When a customer uses TPS65982 and BQ Battery Charger (for example BQ24780) in their application together, will ACDRV Pin of BQ Battery Charger be unused?
(Does TPS65982 perform a opening/closing of the FET of each power supply line?)

Figure79(in DataSheet)

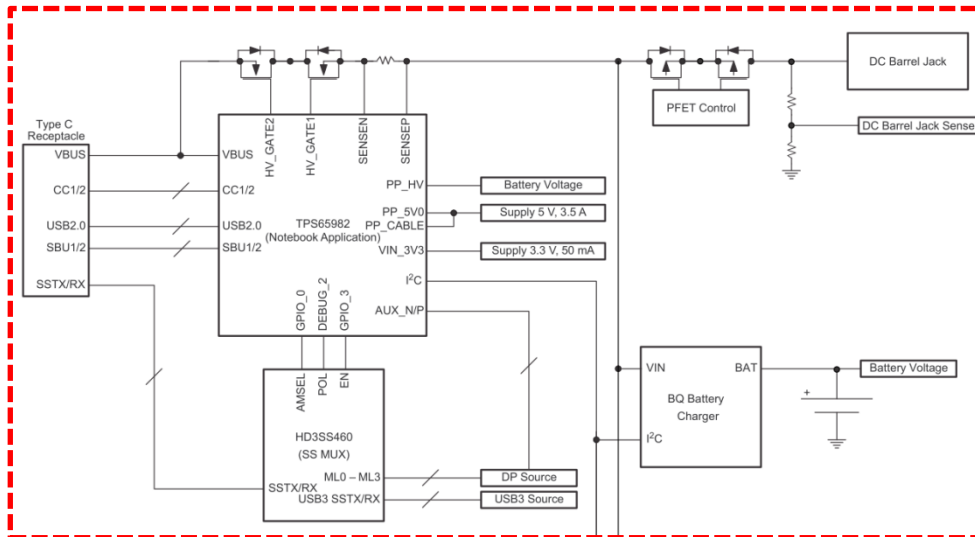
Is there the circuit sample design when customer uses TP65982 and BQ Battery Charger together? Will you provide it to us if there is it?

Figure 79. Dual-Port Notebook Application

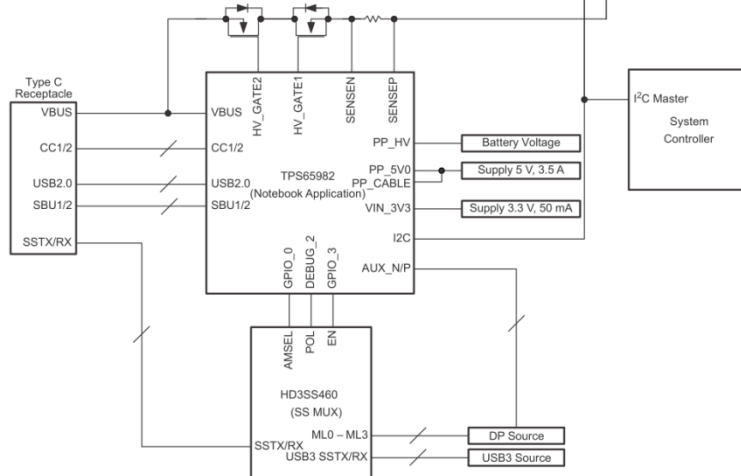
Is there the detailed circuit sample design of this point?
